**CITY OF PALO ALTO  
CITY COUNCIL  
Special Meeting  
Monday, April 29, 2024  
Council Chambers & Hybrid  
5:30 PM**

2. Review of Rail Grade Separation Alternatives for the advancement of the alternatives into the preliminary engineering and environmental documentation phase; CEQA status – statutorily exempt under CEQA section 15262 (feasibility and planning study).

## City Council Staff Report

# Churchill Partial Underpass w/ Kellogg Undercrossing

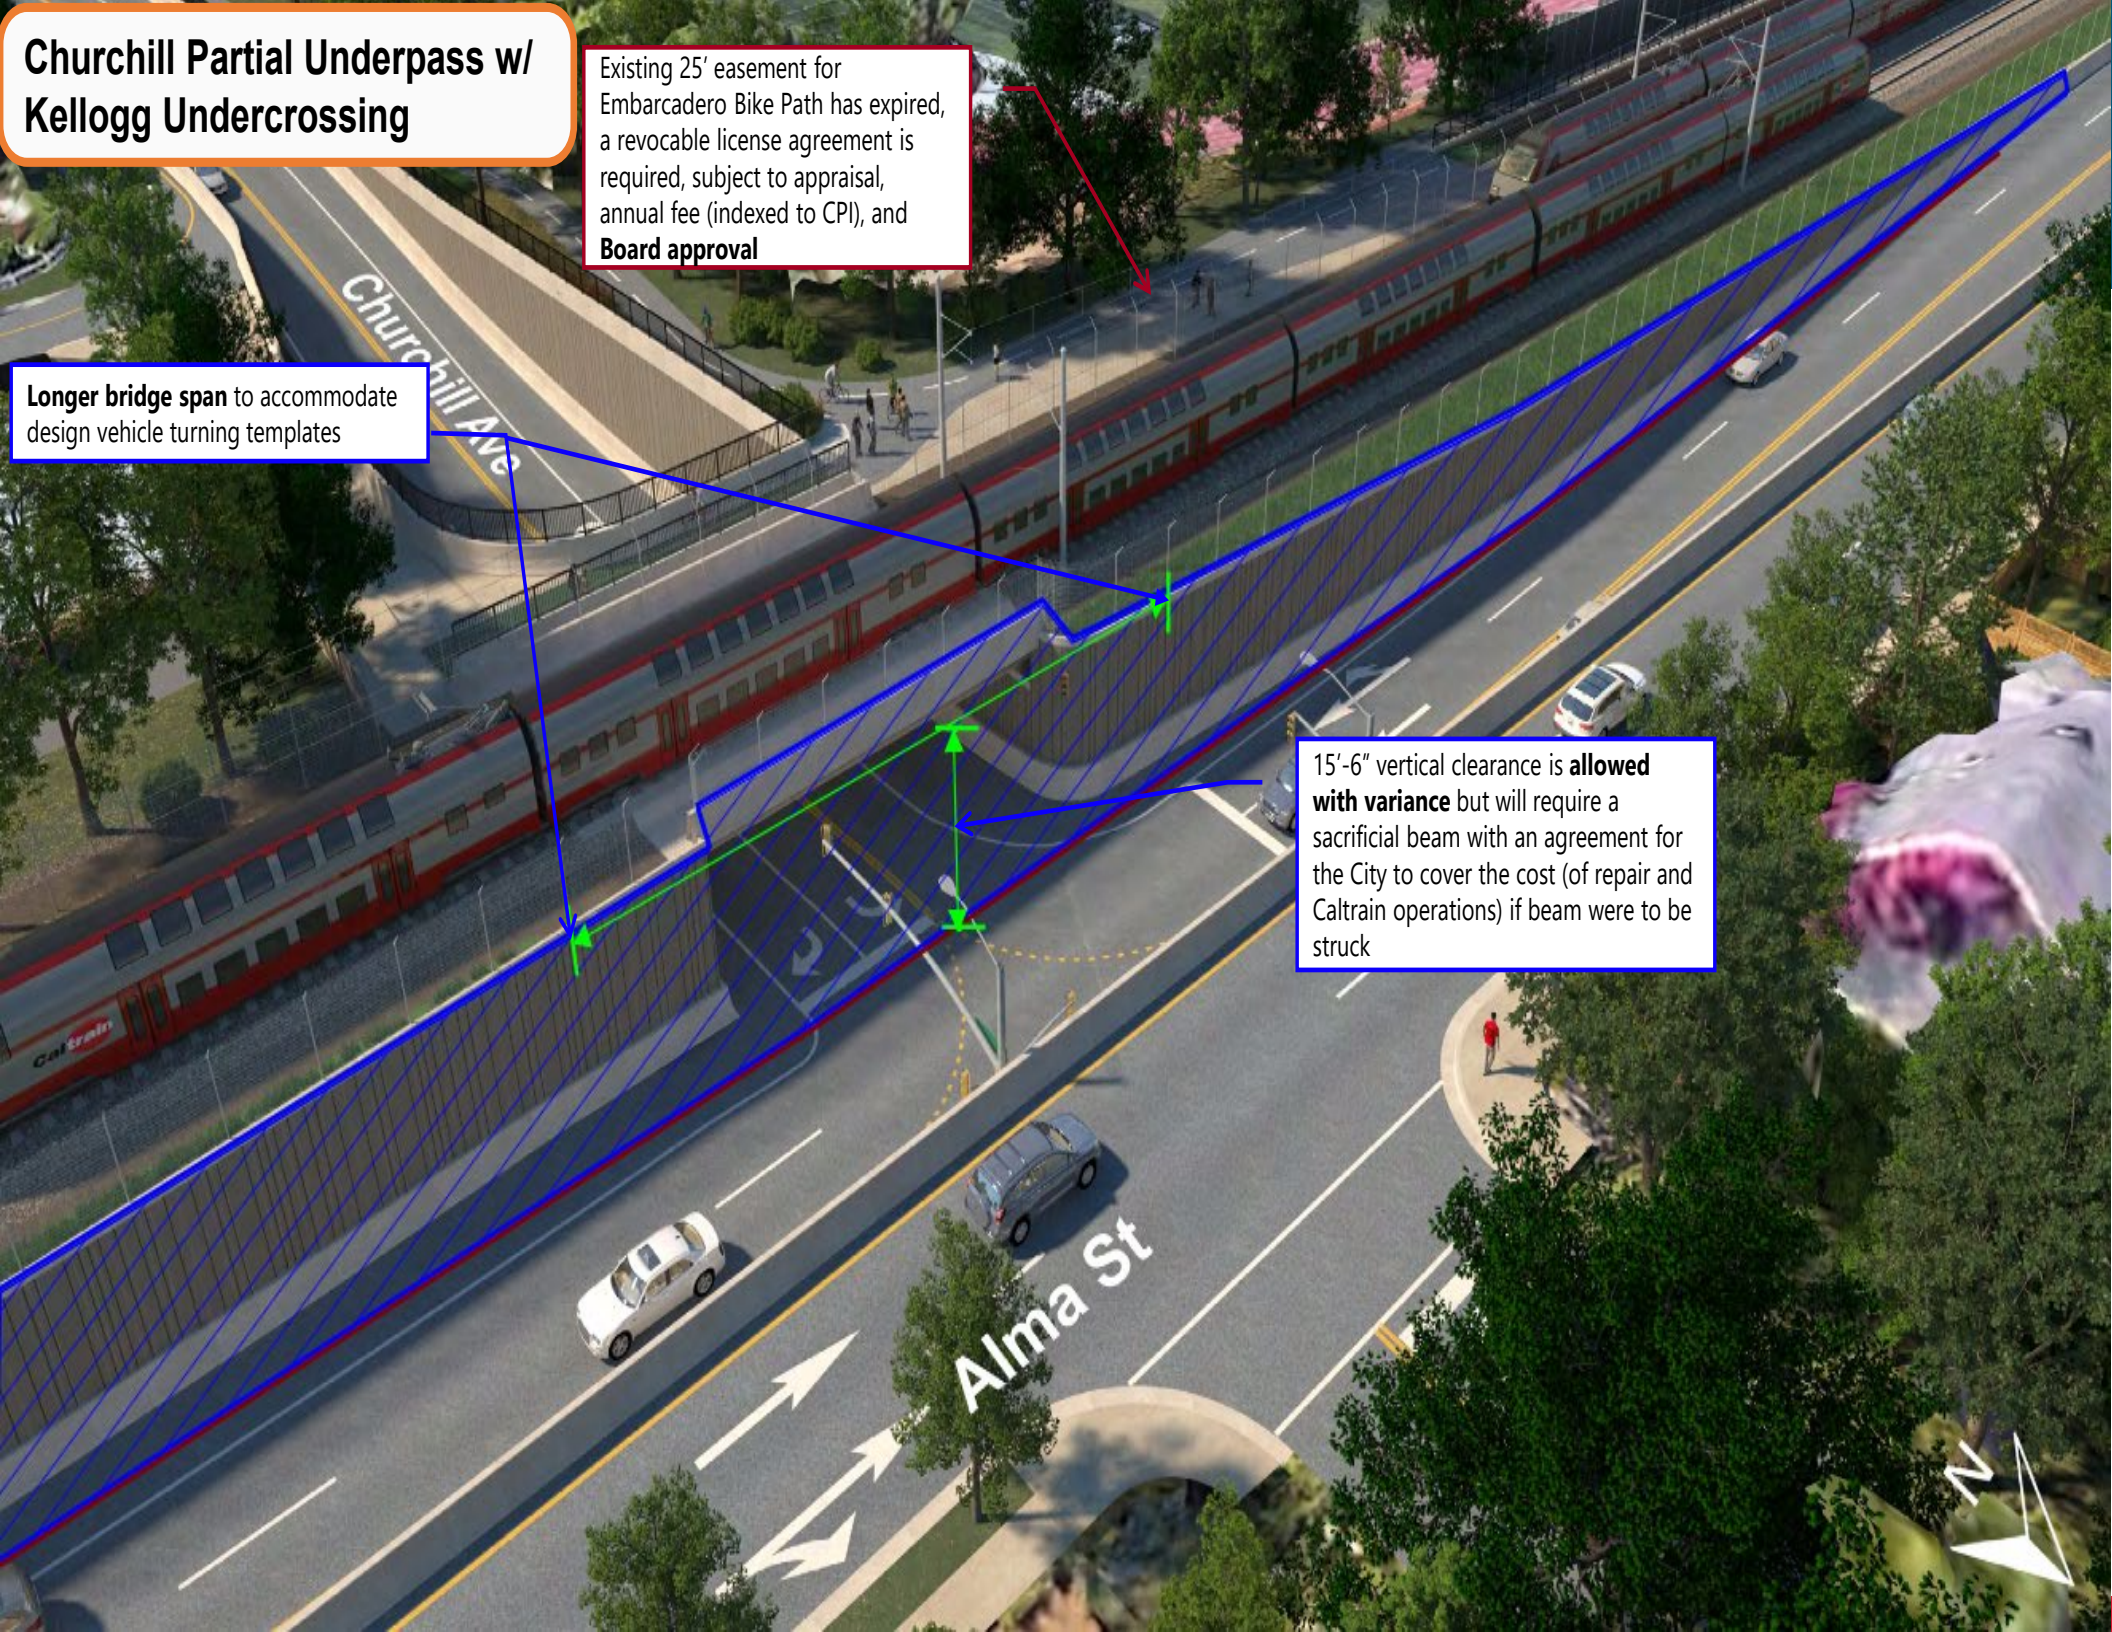
Existing 25' easement for Embarcadero Bike Path has expired, a revocable license agreement is required, subject to appraisal, annual fee (indexed to CPI), and **Board approval**

**Longer bridge span** to accommodate design vehicle turning templates

# Meadow/Charleston Hybrid

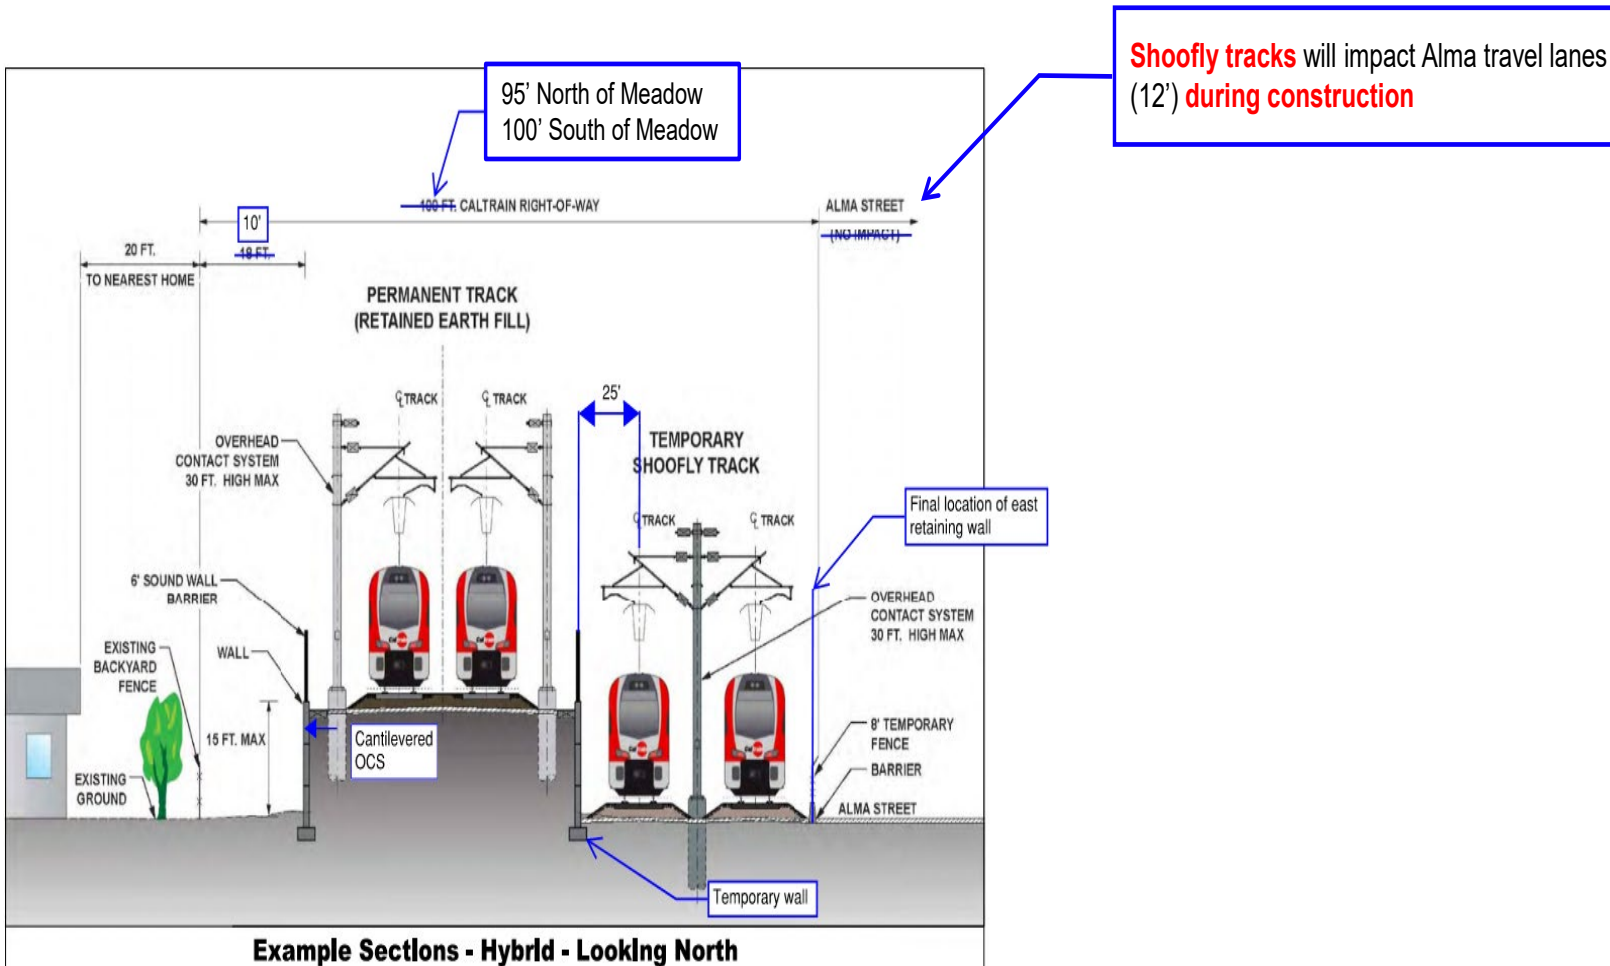
Shoofly tracks will impact Alma travel lanes (12') during construction

# Meadow/Charleston Hybrid

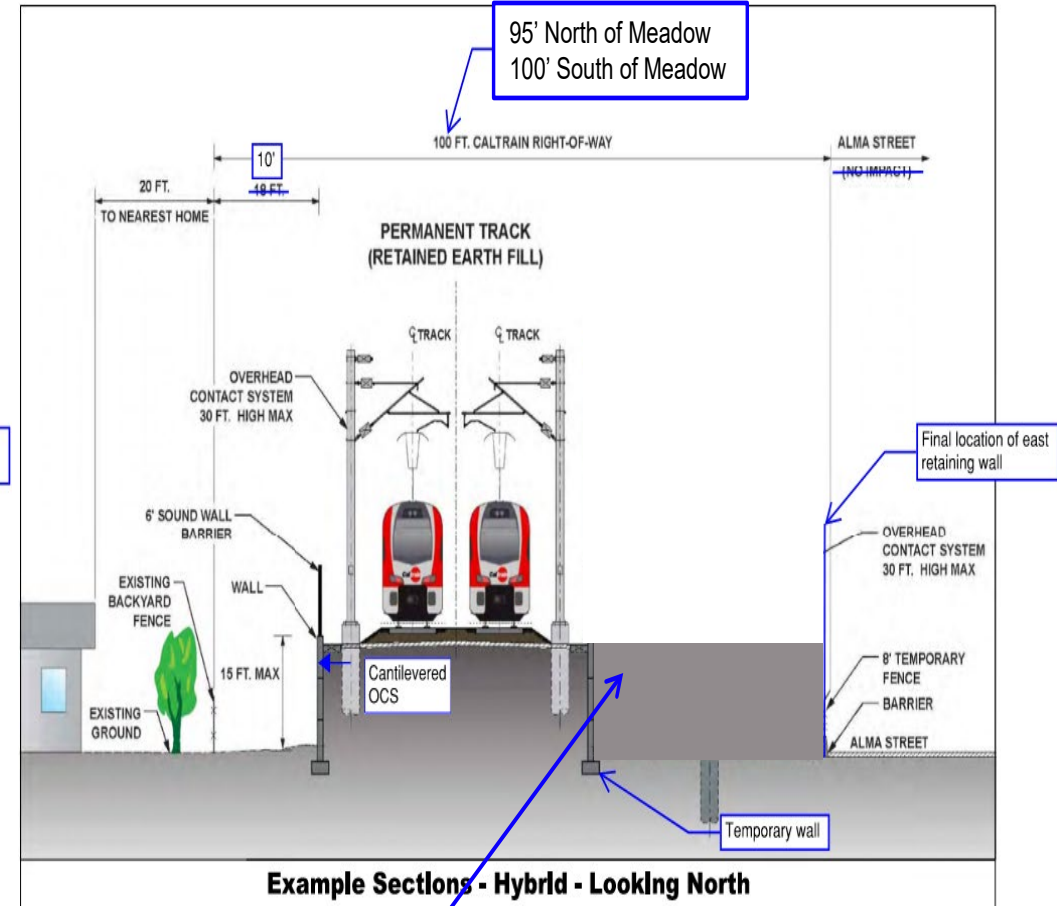
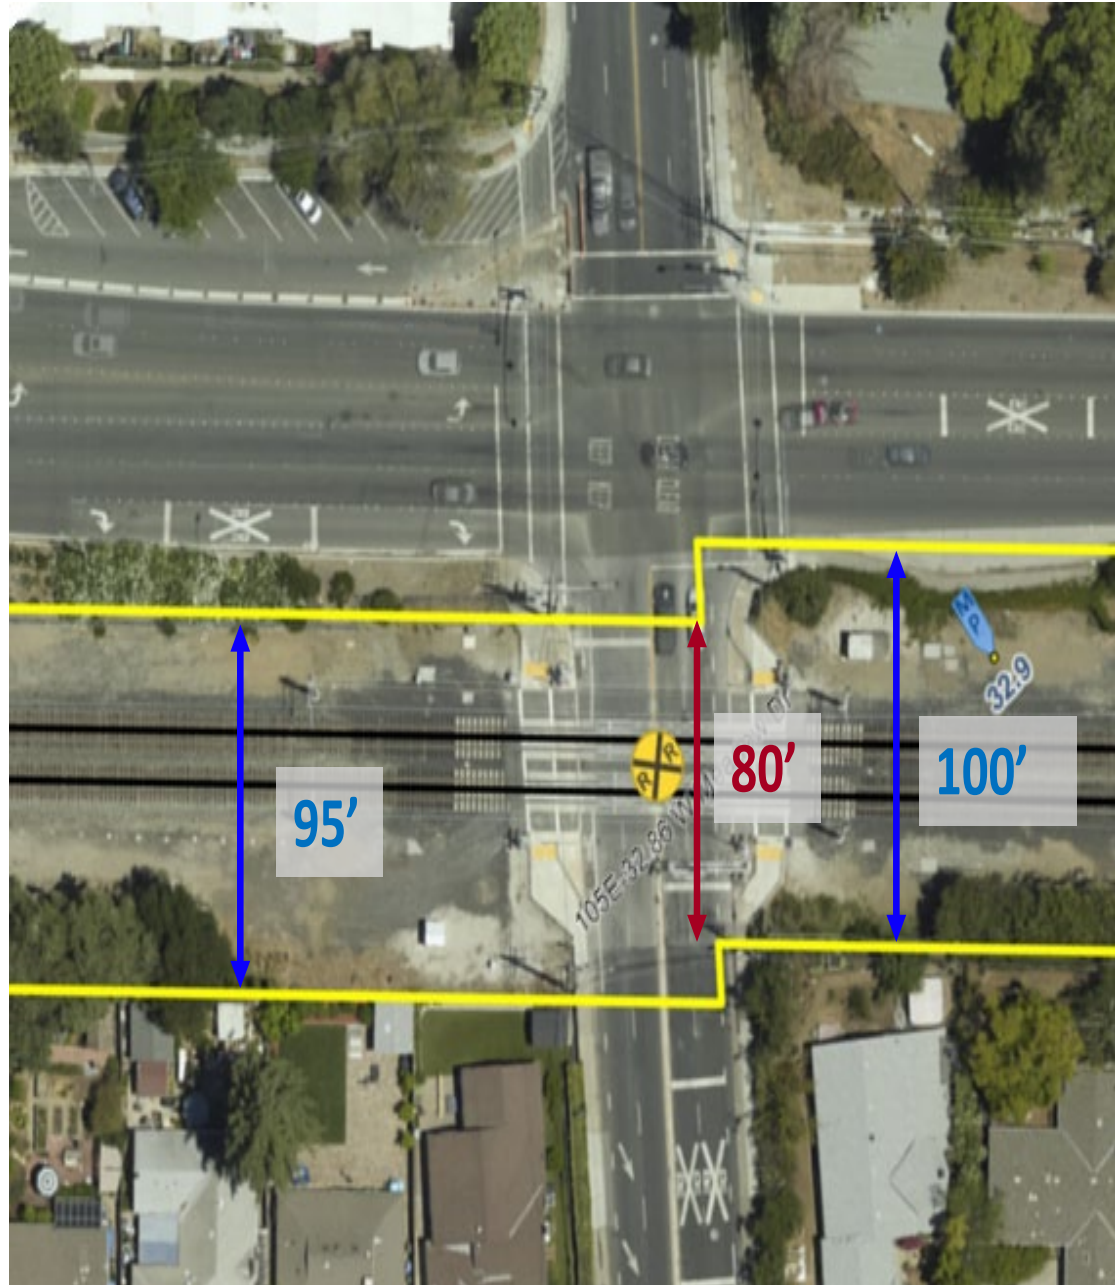
Retained fill between temporary wall and Alma Street wall to maintain utility of Caltrain operating ROW.

# North of Meadow Viaduct

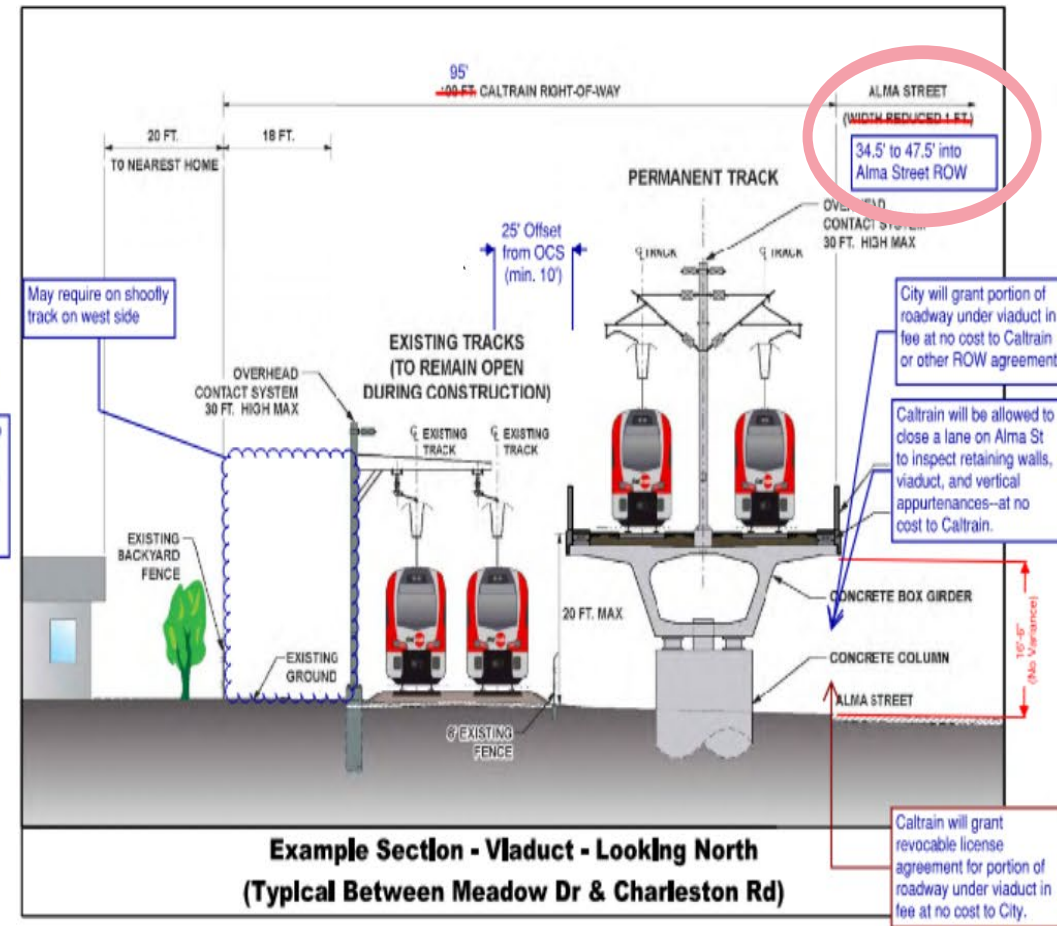
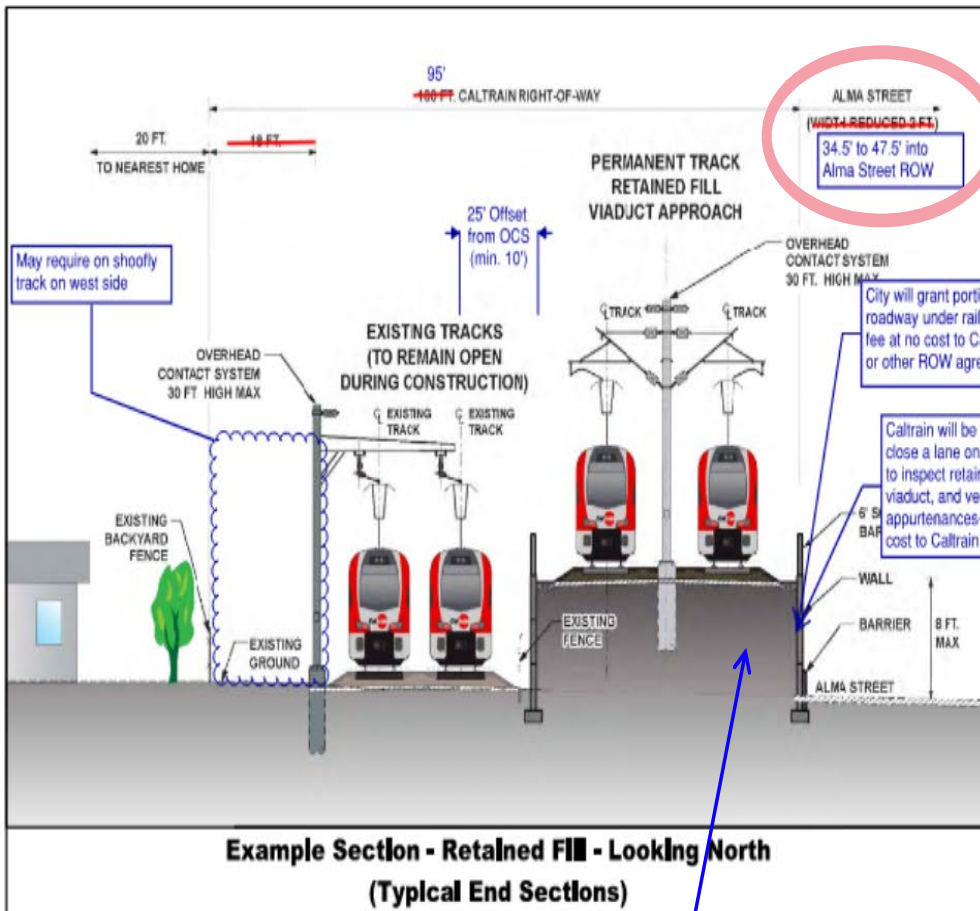
Approach structure approximately **1,600 feet** long **south** of Charleston Road and **2,000 feet** long **north** of Meadow Dr

# South of Meadow Viaduct

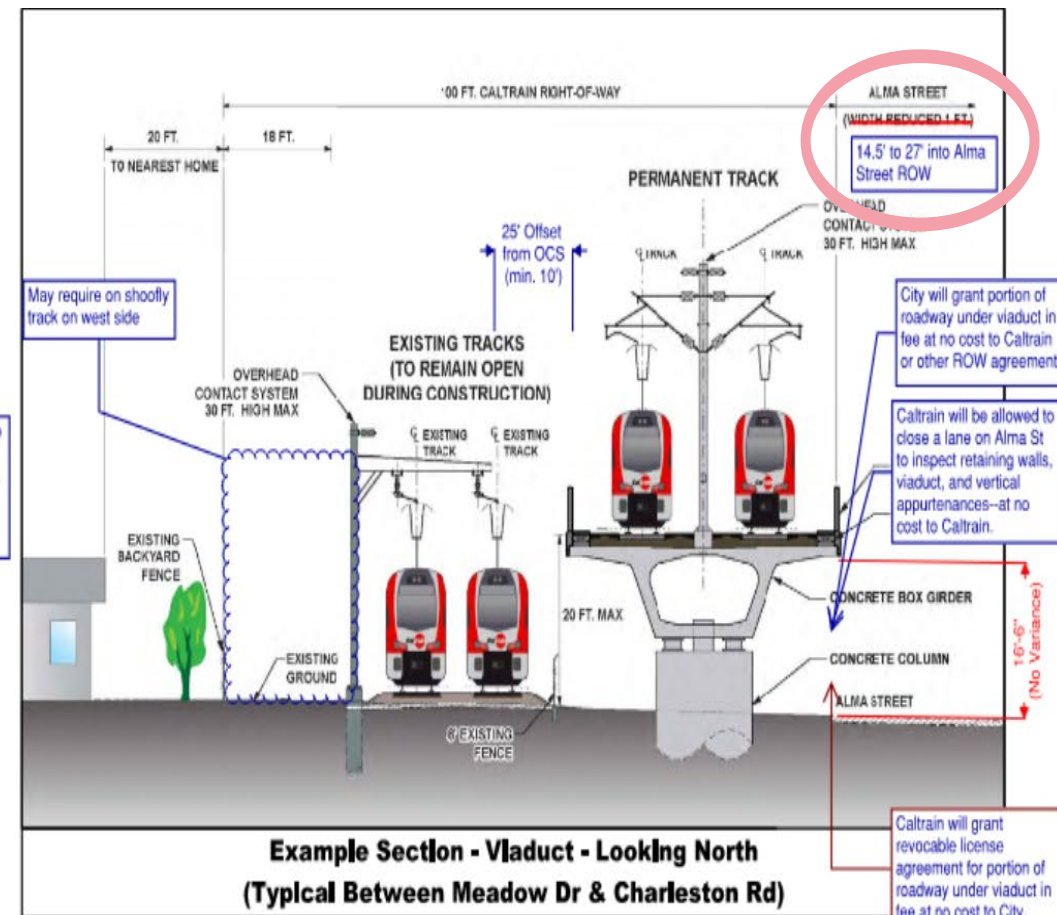
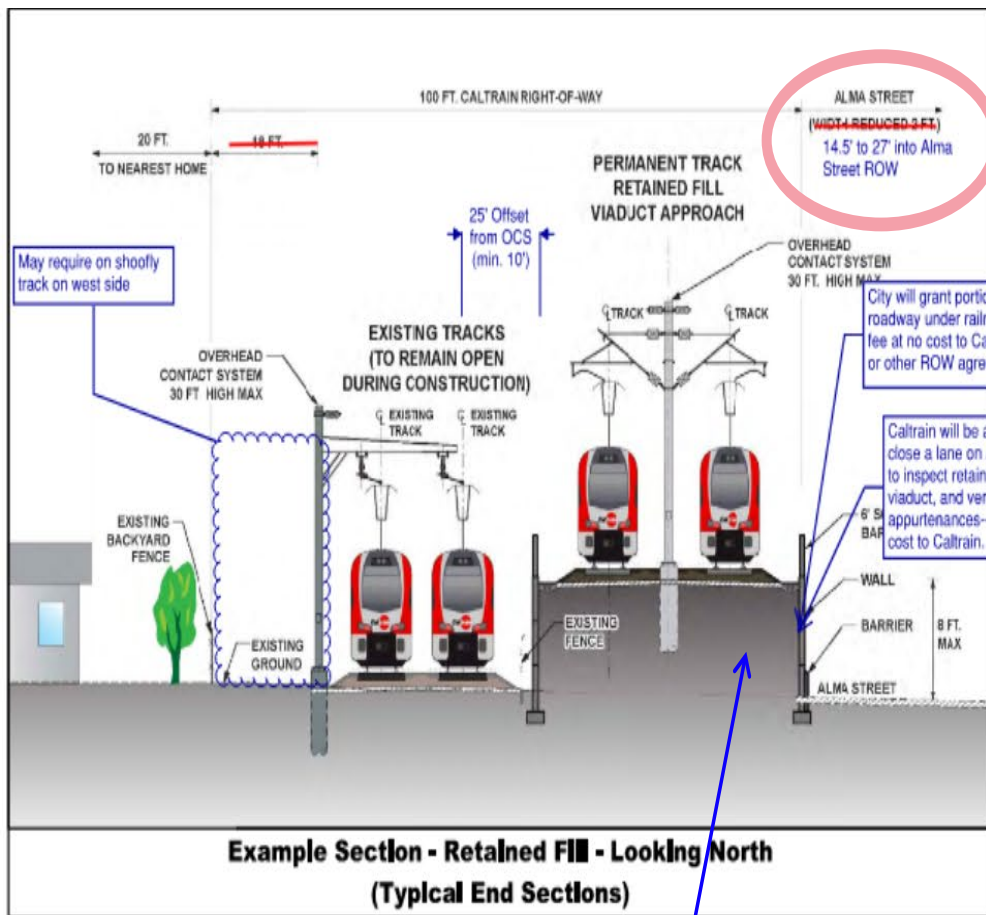
Approach structure approximately **1,600 feet** long **south** of Charleston Road and **2,000 feet** long **north** of Meadow Dr
